Clause 175 1.6TBASE-R hi_ser Timing and Codeword Count

Eric Maniloff – Ciena

IEEE P802.3dj

March, 2026 Vancouver, Canada

1.6TbE PCS/FEC Architecture Evolution : Rx Flow

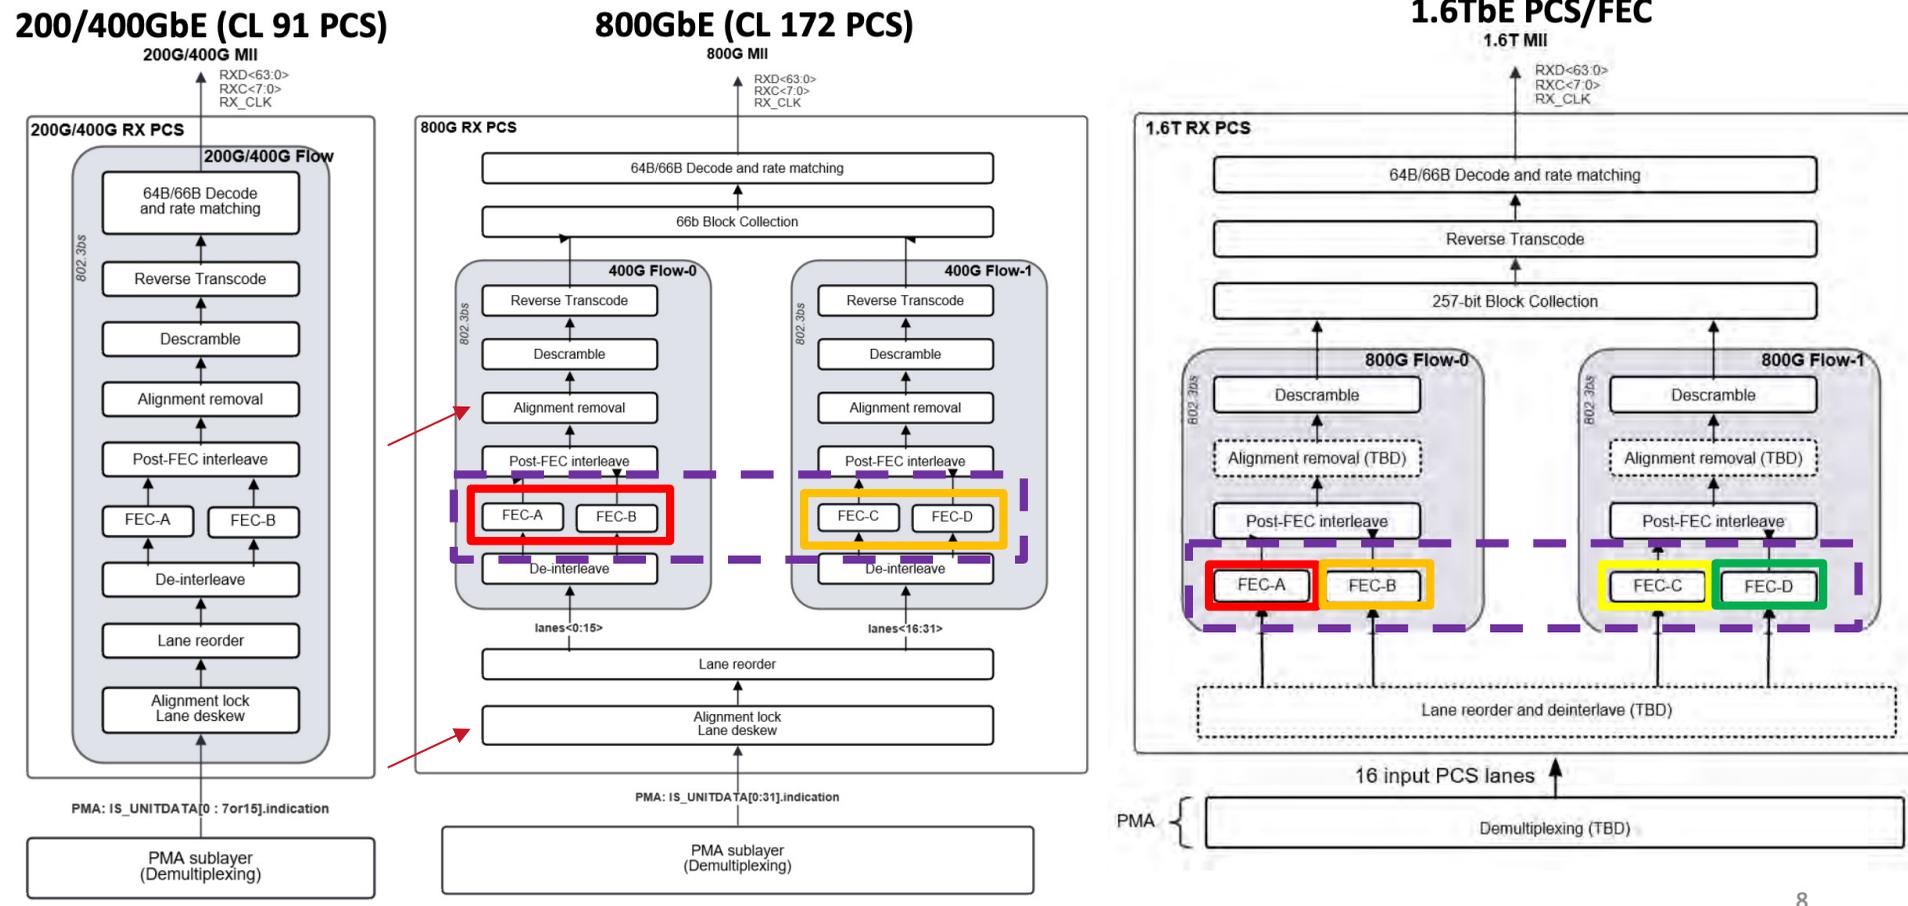
A simplification would be to allow each FEC instance to calculate hi_ser independently

- This is consistent with 800GBASE-R
- A logical OR of each FEC flow would report hi_ser
- No logic to add symbol errors from different flows or Codeword counter is required
- More robust to short error bursts

In 802.3dj hi_ser accumulated across 25% of an AM interval summed across FEC-A,B,C,D

Recommendation is to calculate hi_ser across 8192 FEC codewords per FEC instance mapped into one hi_ser report
